Modified DECISION RECORD
For
Yates Petroleum Corporation
All Day POD
ENVIRONMENTAL ASSESSMENT –WY-070-08-026

This is a modified decision record; it is not a new decision record. This modified decision record augments the decision record in the specific 12 issues addressed in SDR WY-2010-030. In summary those issues generally included the deferral or denial of 9 applications for permit to drill (APDs), 9 impoundments, and conditions on a utility corridor. New information is used to augment the analysis and rationale, and thus complete the environmental record of review. Some of the new information, analysis, and decisions result in changes to conditions of approval (COAs). New COAs replace the earlier COAs.

Figure 1. Dry Willow Bald Eagle Winter Roost Location, 0.5-Mile Buffer and Proposed Location of All Day Endless #1 CBM Well Location

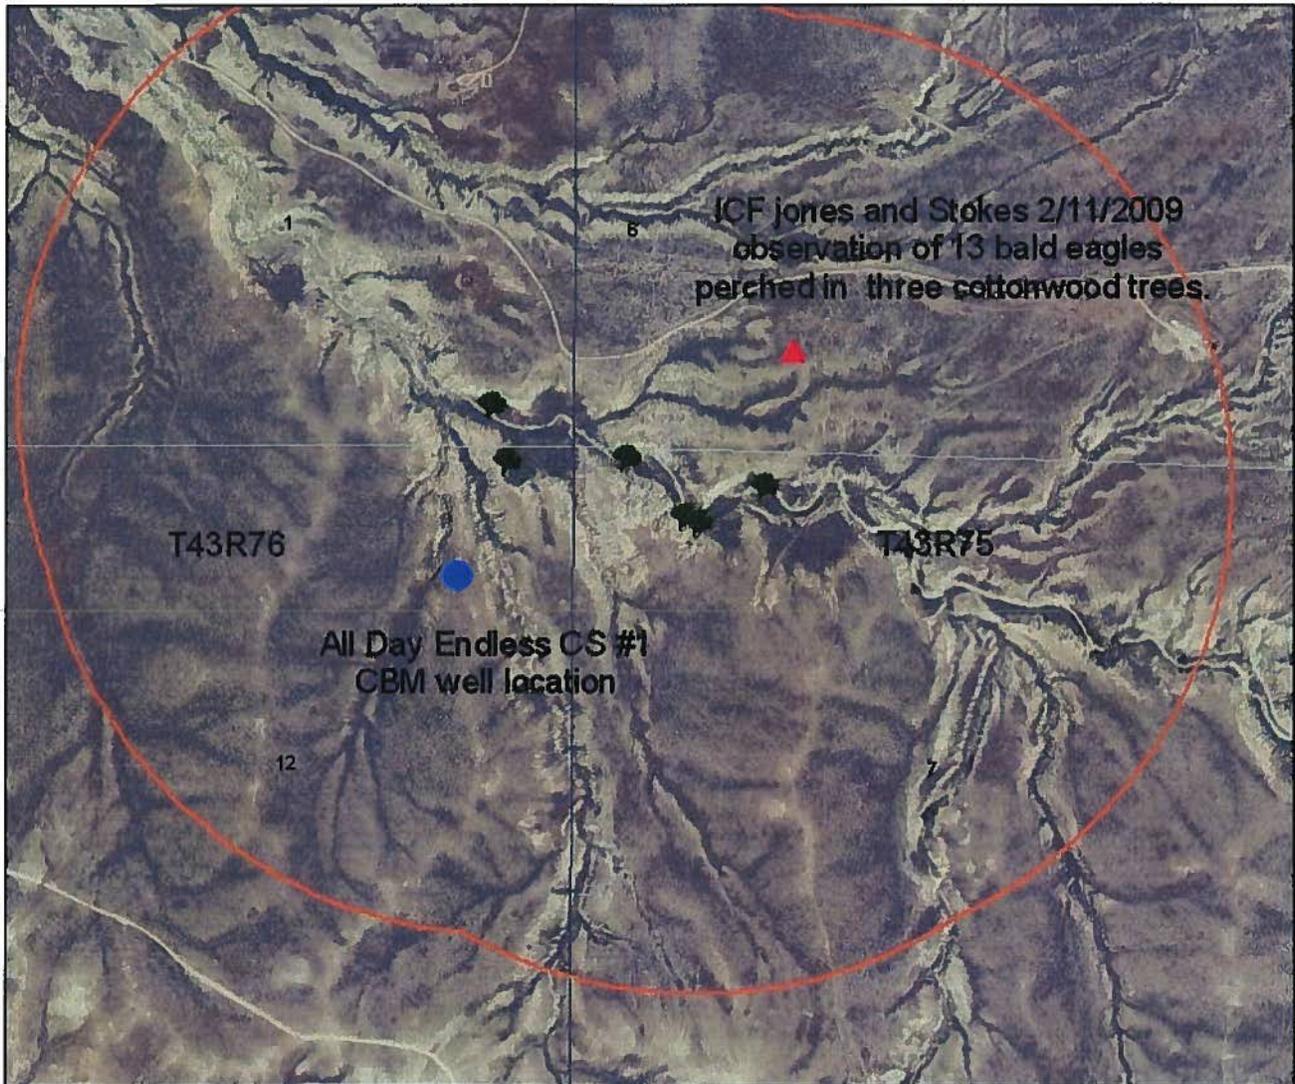
The December 28, 2010 FWS coordination letter (Appendix 3) identifies that the standard conservation measures for raptors in the current RMP are not as effective as originally anticipated, and here are not adequate to prevent violations of the MBTA and BGEPA. If the ALL DAY ENDLESS CS 1 Well is constructed and operated where proposed, then the bald eagle winter roost and golden eagle nest site #4528 will foreseeably become permanently compromised, resulting in a violation of the BGPTA and MBTA by causing nest site abandonment, breeding or fledging failure, and harassment. The bald eagle roost co-located with the golden eagle nest shows consistent use by bald eagles and was recorded as a communal roost with 13 bald eagles documented on February 11, 2009. The proposed well location and roost area were visited on December 21, 2010 to confirm the roost location, determine activity, and further investigate site-specific conditions. The roost is associated with a group of cottonwoods in the Dry Willow Creek channel. At the December 21, 2010 site visit, 6 eagles were seen using trees in Dry Willow Creek: 2 eagles flushed from a tree approximately 0.2 mile to the north of the proposed well location in response to the 2 pick-up trucks approaching the well location, and 4 eagles were seen in association with cottonwoods extending upstream (south) approximately 0.3 mile.

(2) Site-specific circumstances and scientific justification distinguish this nesting location and preclude the well's approval. The timing limitation prescribed in Appendix A, of the Buffalo RMP PRB ROD (2003) is analyzed in consideration of the spatial relationships, line-of-site, and site-specific analysis of this nest and roost to the adjacent proposed APDs. As the site-specific coordination by the US Fish and Wildlife Service noted, ALL DAY ENDLESS CS 2 Well is also within 0.5 mile of the roost (a parameter invoking the timing limitation). The ALL DAY ENDLESS CS 2 Well location is at the outer range of the 0.5 mile roost buffer (0.47 mile), is not within line-of-site of the roost, and is immediately adjacent to an existing, heavily used road. The ALL DAY ENDLESS CS 2 Well can be reasonably constructed, operated, and maintained without causing undue harm to eagles at the nest or roost or resulting in a foreseeable violation of the BGPTA or MBTA.

The USFWS comments for this project (All Day SDR) are attached as Appendix 3 and incorporated here by reference. In summary they request any future federal wells be drilled outside the 0.5 mile buffer from the Dry Willow Roost.

Buffalo Field Office Reply and Rationale: The Buffalo Field Office denies the ALL DAY ENDLESS CS 1 Well.

ALL DAY ENDLESS CS 1 Well: denied due to impacts to bald eagle roost, as described below
